-0 PBY-5A ...

NAME INSTALLATION - ASB RECTIFIER POWER UNIT

J 28F7623

SECTION A-A
SCALE 12" = 1'-0"

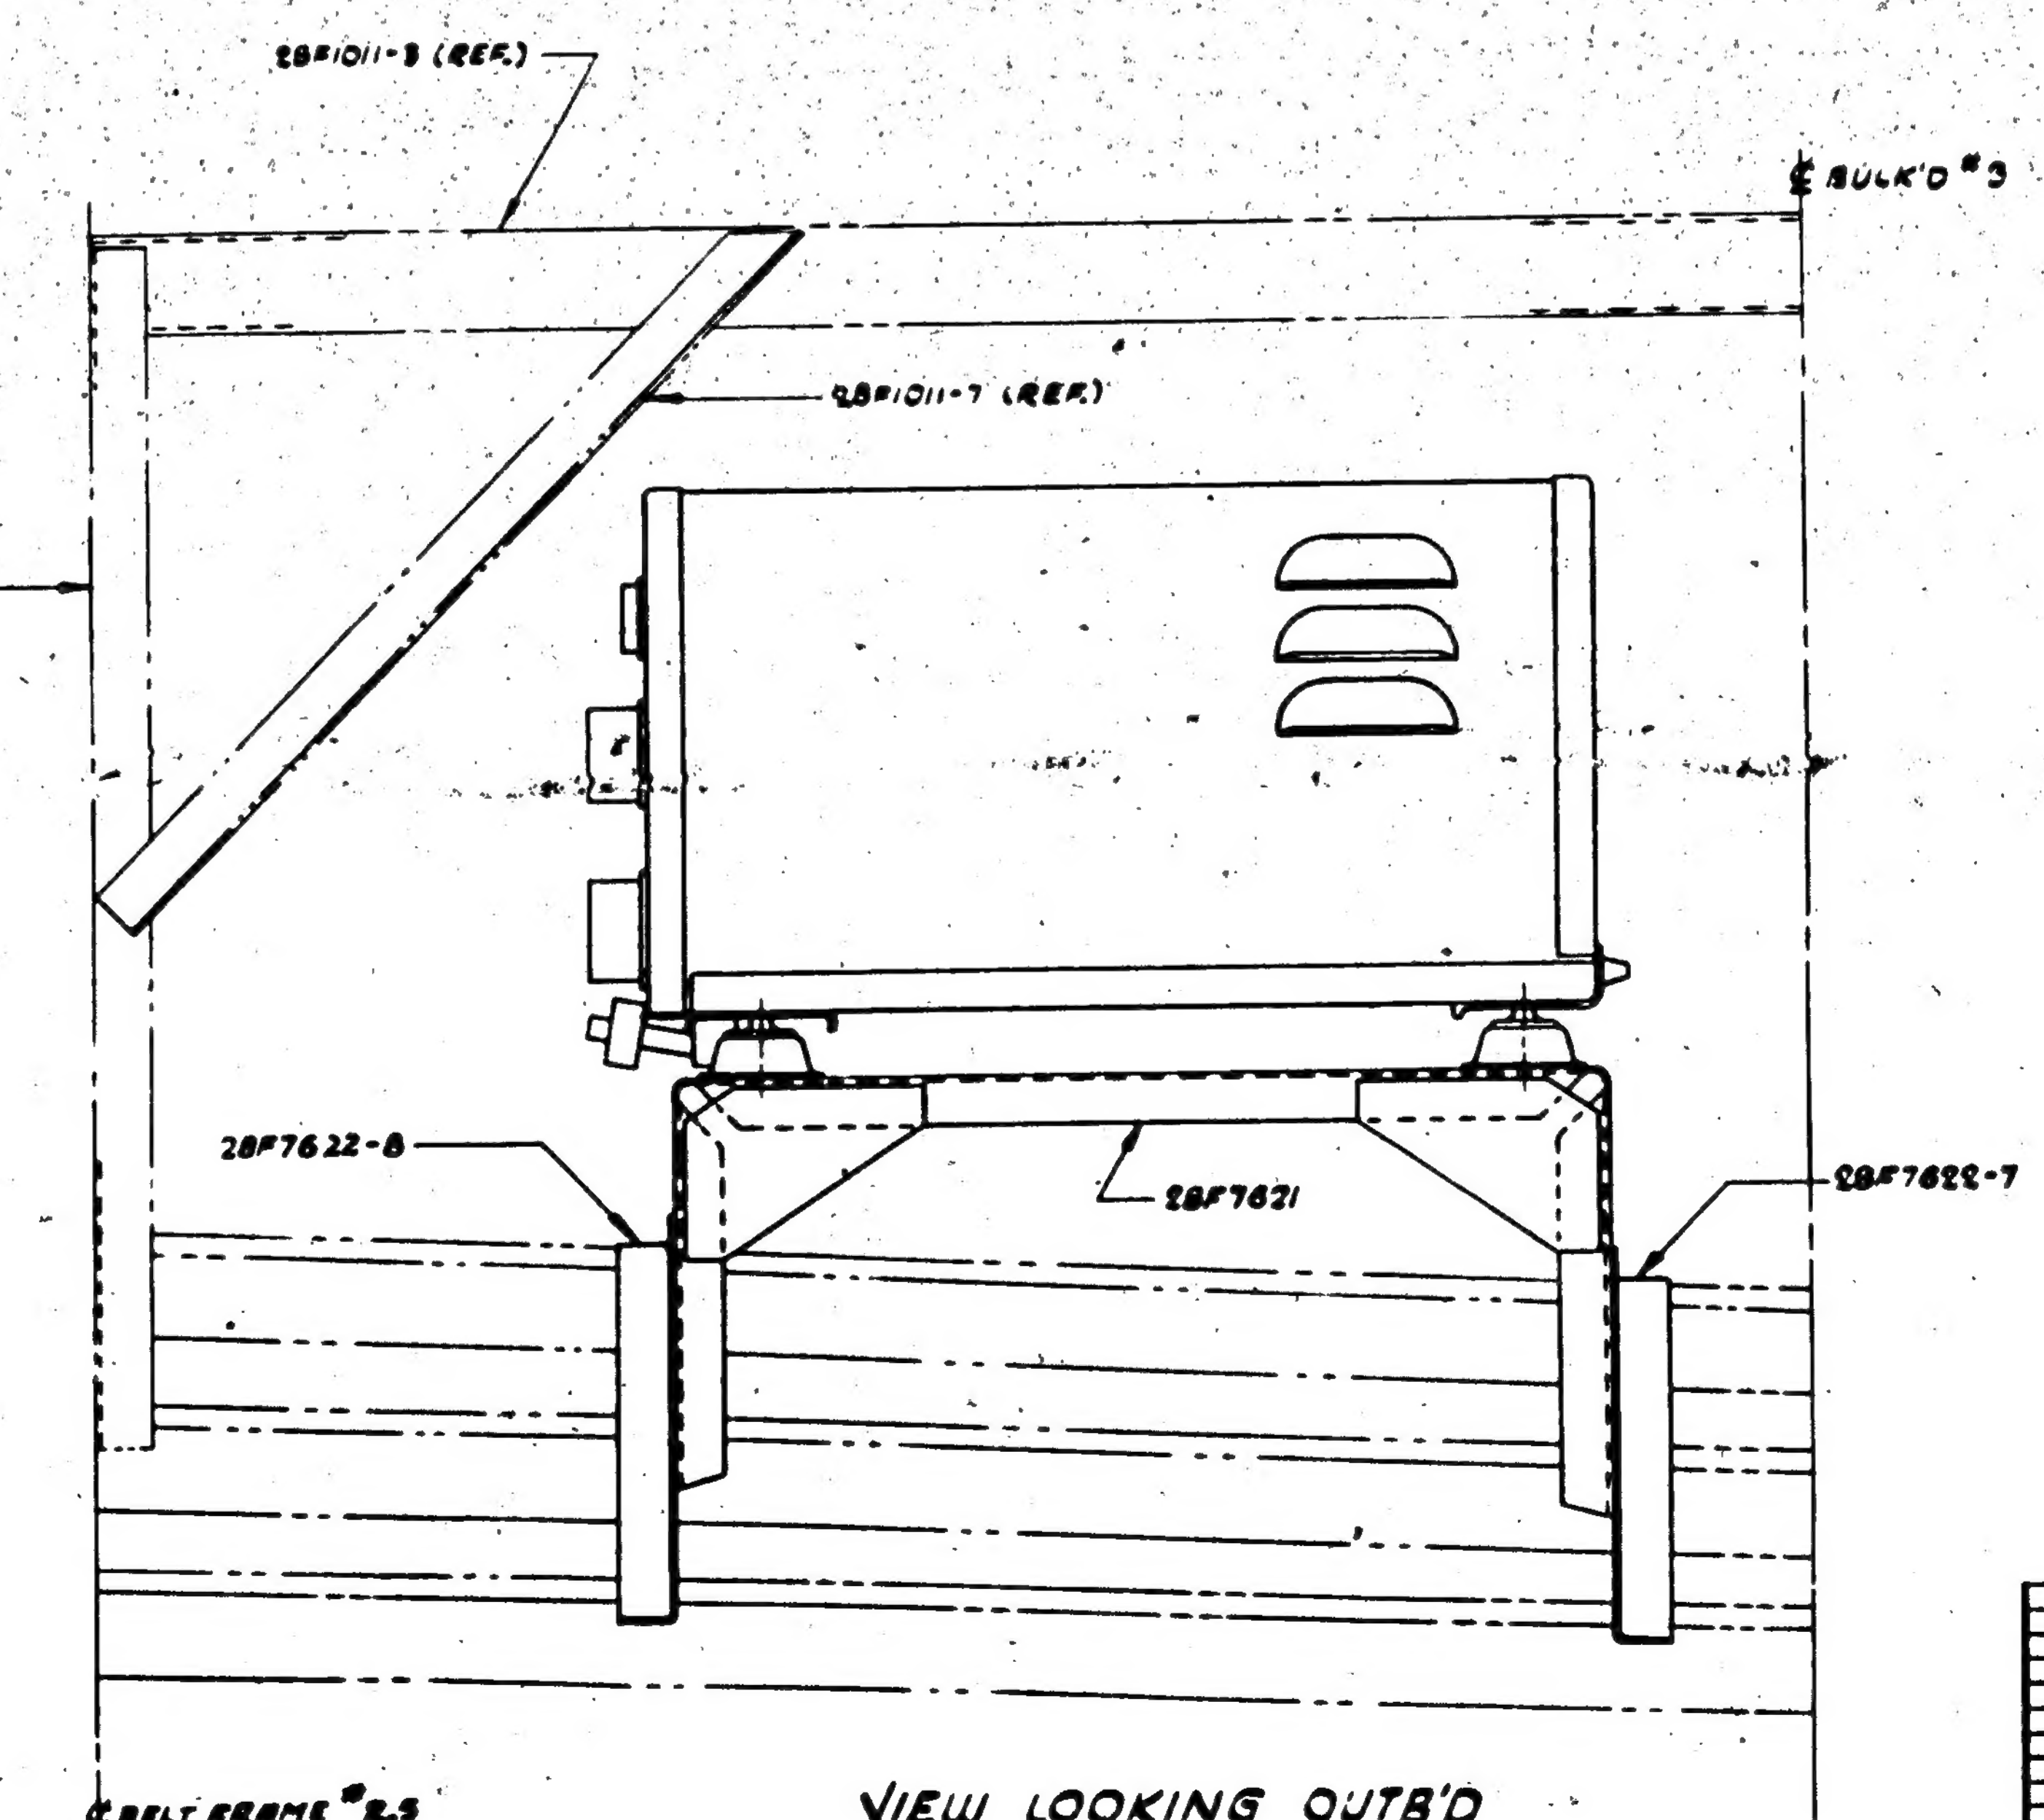
LET	ALTERATION	DATE	BY	LET	ALTERATION	DATE	BY
				A	IN B/M & ON FACE, REMOVED AN442-AD4 RIVETS (18 PLACES) & REPLACED WITH Q5106 D10-7 (18 REQ) & AC 372-D1032 (18 REQ) NEG. WT. CHG.
